STEREO IMPACT

PROBLEM REPORT

PR-7002

SEPT-Detector

Figure: Junction side wire bonding

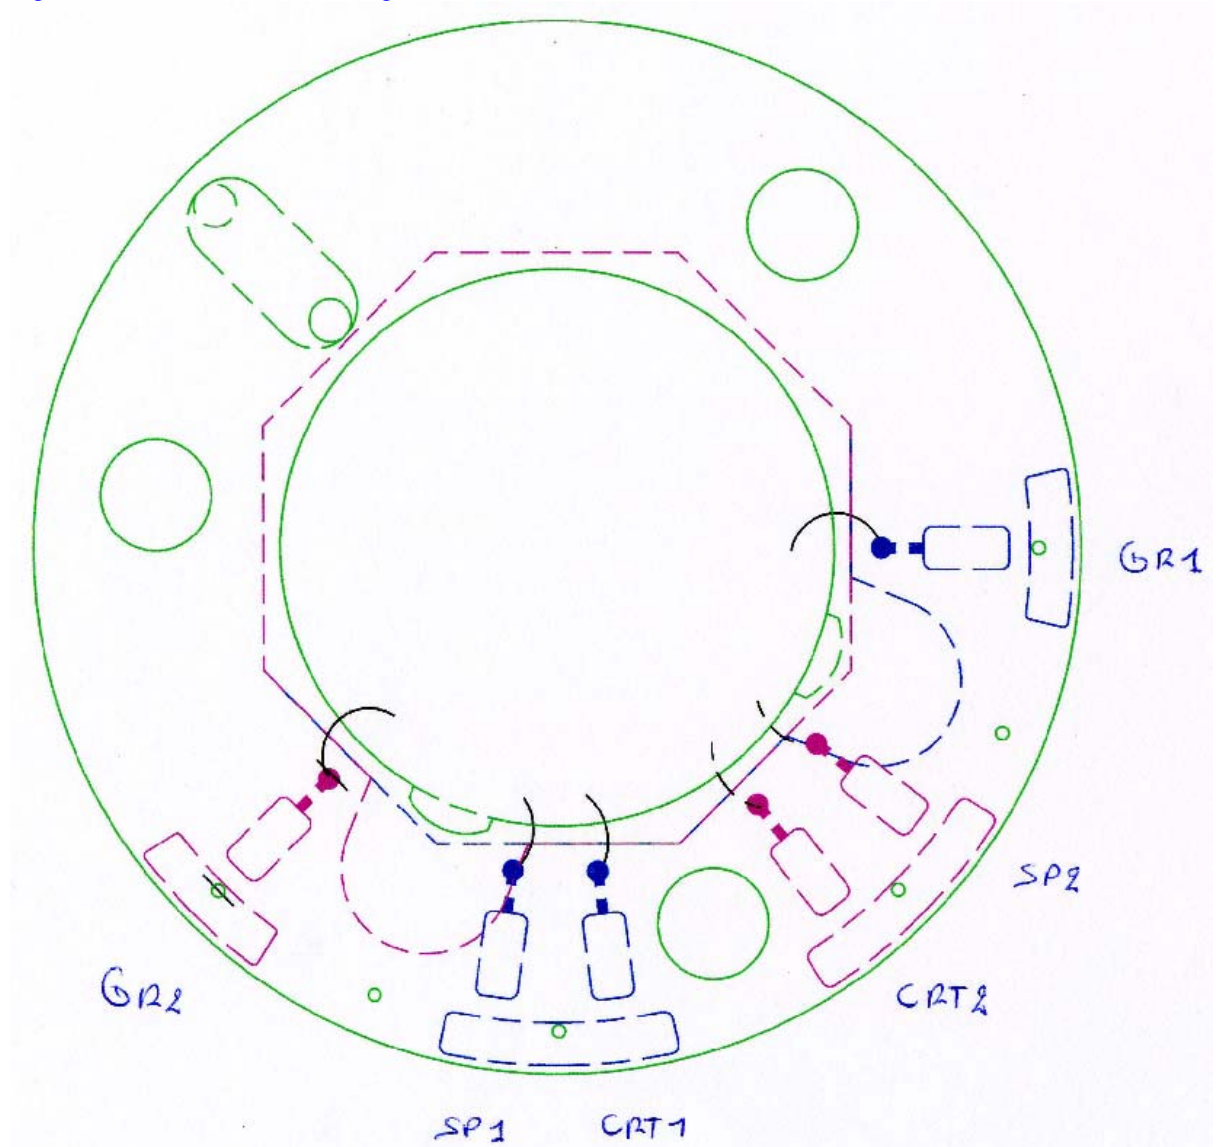
- The detectors are glued with EPO-TEK E4110-LV (formerly EP110-LV) to PCB frames. Differences in thermal expansion coefficients between frame, glue, and silicon might exist. Kiel had never operated detectors below $-30\text{ }^{\circ}\text{C}$ and cannot test below $-30\text{ }^{\circ}\text{C}$. Canberra/Belgium cannot test detectors below $-10\text{ }^{\circ}\text{C}$.
- The 0.1 mm diameter aluminium wire-bonds might not have enough clearance (gap between the paired detectors: $700\text{ }\mu\text{m}$). The DELRIN standoffs which define the gap might change with temperature.

The tests at Canberra were successful in revealing the cause of the failure: the height of the arch suspended by the wire bonds is higher than the separation distance of the two detectors in the stack. All eight detector stacks (not only the two failing ones) were disassembled, wire bonds removed, new wire bonds applied with maximum height of 0.6 mm, detectors separated by 1.0 mm instead of 0.8 mm and mounted in new housing. All four sensor units were re-assembled and integrated with their associated electronics units.
